UNITED STATES PATENT AND TRADEMARK OFFICE

APPLICATION NO.	FILING DATE	FIRST NAMED INVENTOR	ATTORNEY DOCKET NO.	CONFIRMATION NO.
10/520,817	01/07/2005	Henrik Lindenskov Nielsen	P70346US0	5100

Office Action Summary	Application No. 10/520,817	Applicant(s) NIELSEN ET AL.	
	Examiner Michael G. Bogart	Art Unit 3761

DETAILED ACTION

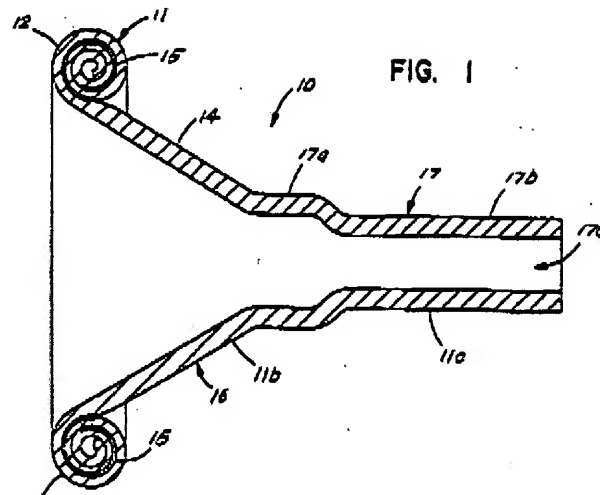
Claim 23 is rejected under 35 U.S.C. § 102(b) as being anticipated by Conway (US 5,376,085 A; hereinafter: “Conway”).

Conway teaches an external urinary catheter (10), comprising a tip portion (16) and a sheath portion (11), said external urinary catheter (10) having at least one area of the external urinary catheter is transparent and/or permeable (col. 5, lines 27-38)(see figure 1, *infra*).

The limitation “manufactured by thermoplastic processing” is a product-by-process limitation. Product-by-process limitations are limited to the recited steps, only the structure implied by those steps. MPEP § 2113. Silicone rubber is a thermoplastic as it is capable of softening or fusing when heated and of hardening again when cooled.

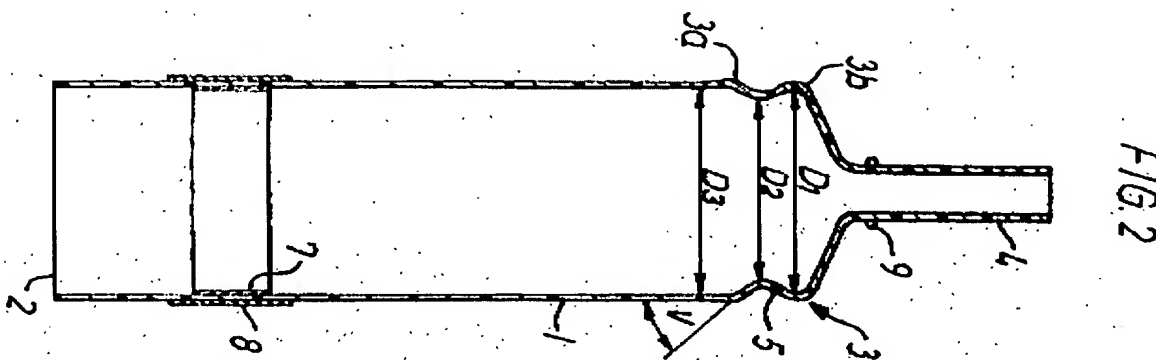
Claims 23-27 and 44, 45 and 47 are rejected under 35 U.S.C. § 103(a) as being unpatentable over Wendler (US 5,554,141 A) in view of Oda *et al.* (EP 1 062 957 A1; hereinafter: "Oda").

Wendler teaches an external urinary catheter (1) and method of making the same, comprising a tip portion (34) and a sheath portion (1), said external urinary catheter (1) having thermoplastic construction (abstract)(col. 5, lines 27-38).

Wendler is silent as to the catheter's transparency.

Oda teaches a flexible, elastic and transparent medical device including a catheter comprising a composition of styrene-ethylene random copolymer and a plasticizer to which further polymeric compounds can be added (paragraphs 0001, 0002, 0008, 0009 and 0065, and 0076).

At the time of the invention, it would have been obvious for one of ordinary skill in the art to use the transparent materials of Oda in the condom catheter of Wendler in order to make it transparent as is required for some medical devices so a caretaker/wearer can see its contents (see Wendler, paragraph 0003).

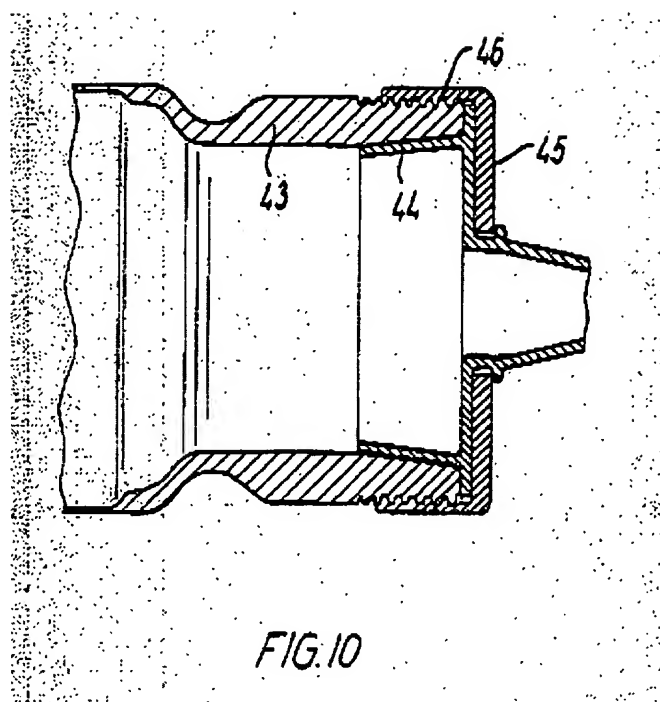
Regarding claims 40 and 41, Wendler teaches a pressure-sensing adhesive (7) and an adhesive rejecting/release layer (8).

Regarding claim 42, Wendler teaches a separate adhesive element (7).

Regarding claim 43, Wendler teaches interlocking elements (46)(see figure 10, *infra*).
